Project Name: TOWN OF CATSKILL WASTEWATER COLLECTION SYSTEM
CONTRACT 3: SANITARY SEWER COLLECTION SYSTEM

Section 11217 - Grinder Pump Systems

SUBMITTAL RESPONSE

SUBMISSION FOR APPROVAL

UNLESS OTHERWISE SPECIFIED: DIMENSIONS ARE IN MILLIMETERS SURFACE FINISH: TOLERANCES: LINEAR: ANGULAR:		PUMP & DISCONNECT: RAIL: PUMP: LIBERTY LSG202 SO: 277596 PO:		DO NOT SCALE DRAWING	REVISION 02
TITLE: EMMONS PUMP & CONTROL				PO#: TOWN OF CATSKILL	
DWG NO. 277596 D		MATERIAL:		A2

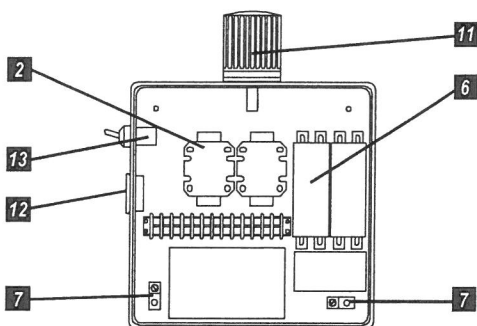
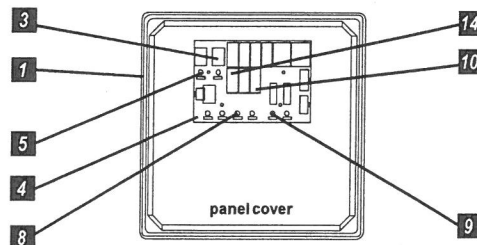
1. SUBMITTAL #2 -- 11217.2 -- GRINDER PUMP SYSTEMS
 - 2.02 SIMPLEX/DUPLEX GRINDER PUMP SYSTEMS
 - 240 AND 230 VOLT IS THE SAME.
 - THE FIBERGLASS COVER IS 30-3/16" OD. IT IS CALLED A 24" COVER AS THIS IS THE INSIDE DIAMETER OF SIMPLEX TANK SYSTEMS.
 - THE JUNCTION BOX CONDUIT COUPLING HAS BEEN CHANGED TO 2". DRAWING HAS BEEN CHANGED AS WELL.
 - THE LIMITED WARRANTY FOR LIBERTY PUMPS IS 3 YEARS. THE LIMITED WARRANTY FOR SJE/RHOMBUS CONTROLS IS 5 YEARS. THE LIMITED WARRANTY FOR TOPP TANKS IS 3 YEARS.
 - 3.02 SUBMERSIBLE PUMPSS
 - THE PIPE FOR GUIDE RAILS HAS BEEN CHANGED TO 1". THE RAILS ARE 304 SST, SCHEDULE 40. DRAWINGS HAVE BEEN CHANGED TO 1" GUIDE RAILS.

277596 A

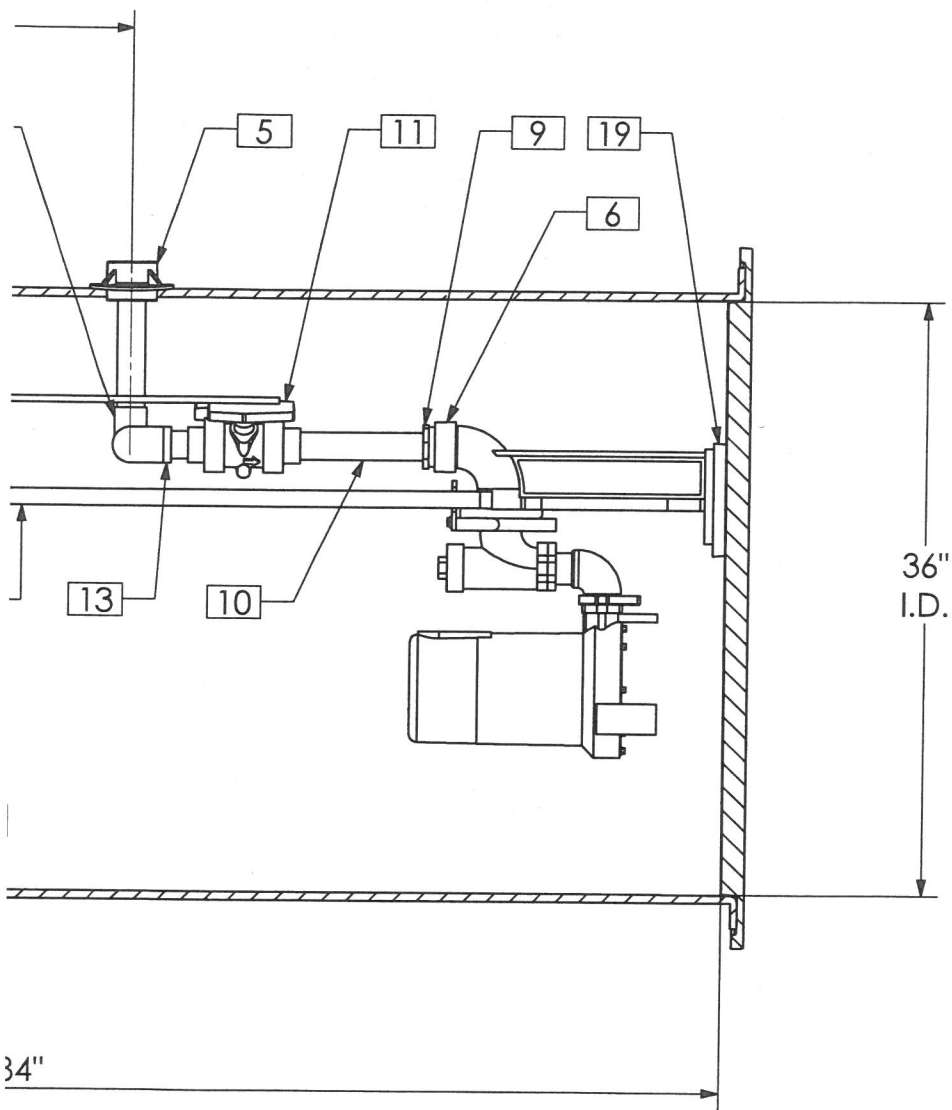
1. Submittal #2.1 – 11217-2 – Grinder Pump Systems
 - 2.02 – Simplex/Duplex Pumps Grinder Pump – **Approved as Noted**
 - Duplex Pump- 4 Float Operation to be used
 - Shop drawing shows 4 float set up with lead, lag, stop and alarm floats.
